GXV3380 Firmware Release Notes

GXV3380

07/26/2021

ACCOUNT SETTINGS IMPROVEMENT

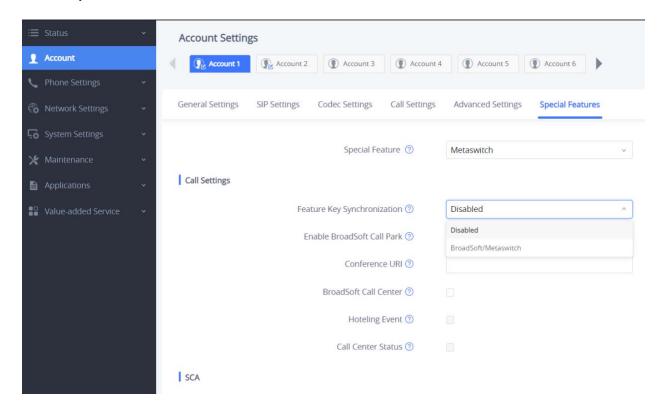
Special Feature tab can be now found under Account settings for each account, where Special Feature, Call Settings and SCA can be found. Feature Key Synchronization setting option to "Broadsoft/Metaswitch". Please find the new layout below.

VQ RTCP-XR

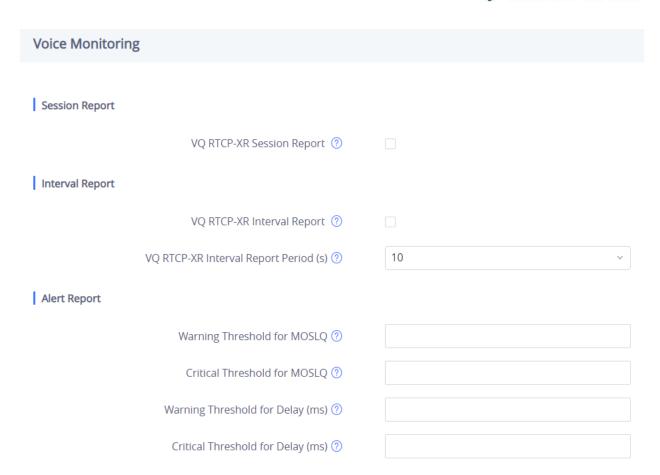
This feature supports the Extended Report (XR) packet type for RTP Control Protocol (RTCP). This feature is located under web UI-> Account-> Codec Settings and Maintenance -> Voice Monitoring.

QUICK DTMF

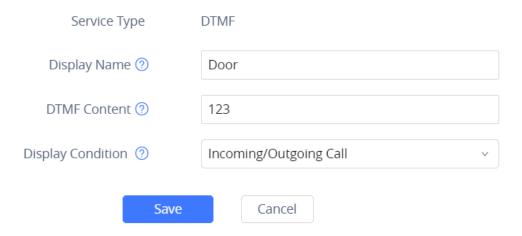
This allows user to use button to enter DTMF. In web UI -> Value-added Services, create a service type for "DTMF", such as an example below.

Then the during the call, press the keypad on LCD to display and use the buttons, shown as below.

PRESENTATION APP

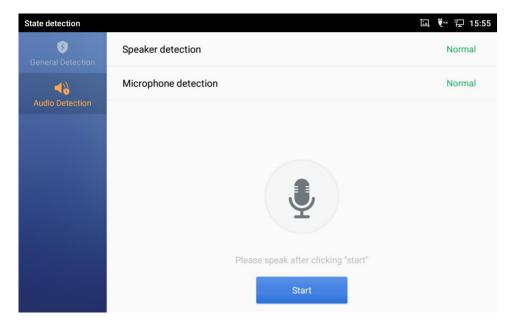
The Presentation app is on device LCD desktop. Users need to connect the device HDMI-in and PC or laptop via an HDMI cable. The audio will also be played from GXV3380.
